**RE: *Indian Hills Unit Well No. 31 (API No. 30-015-31534) Sidetrack Re-Entry
1,093' FNL & 663' FEL, Sec. 20, Township 21 South, Range 24 East (SHL),
2,467' FNL & 496' FWL, Sec. 21, Township 21 South, Range 24 East (BHL)
Indian Basin Upper Pennsylvanian Associated Pool***

By means of this application, Marathon respectfully requests administrative approval for a non-standard location for the proposed sidetrack of the Indian Hills Unit Well No. 31. The current well has a surface location of 1,093' FNL & 663' FEL, Section 20, Township 21 South, Range 24 East. Marathon requests this approval in order to sidetrack and reposition the well to a more southern bottomhole location of 2,467' FNL & 496' FWL, Section 21, Township 21 South, Range 24 East in the Upper Pennsylvanian formation, and the well shall remain dedicated to the standard spacing unit consisting of the east half of Section 21.

From: Stogner, Michael
Sent: Thursday, April 22, 2004 5:13 PM
To: Mark Mick (E-mail)
Subject: Indian Hills Unit #31

Structure : Indian Hills Unit No. 31

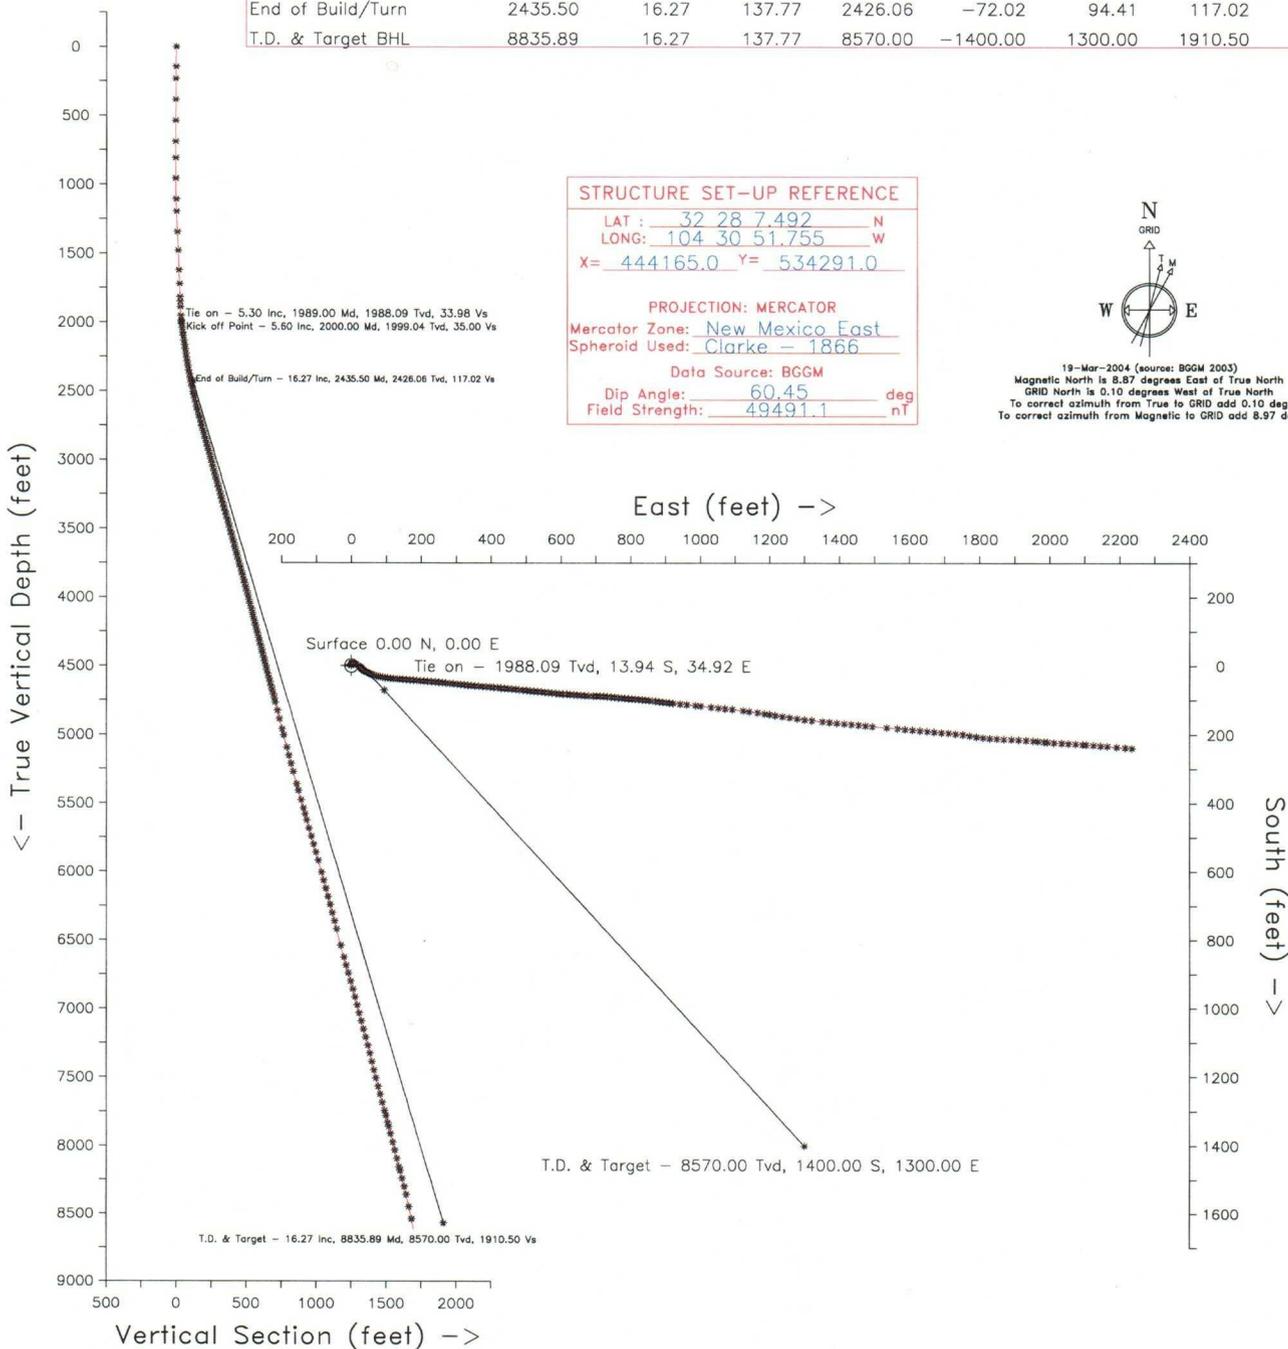
I am in the process of preparing an non-standard location order for your application filed on March 31st. From your application the proposed directional plan anticipates the Upper Pennsylvanian formation will be penetrated at a sub-surface location 2286' FNL & 340' FWL of Section 21.

At what depth is this expected to occur?

In response to your e-mailed question (copied below) regarding Marathon's non-standard location application for the Indian Hills Unit #31, I have provided the penetration depths as you requested. As you mentioned, we anticipate the Upper Pennsylvanian formation to be penetrated at a sub-surface location 2,286' FNL & 340' FWL of Section

21. This corresponds to the following approximate depths:

- -3,610' SSTVD
- 7,780' TVD
- 8,013' MD
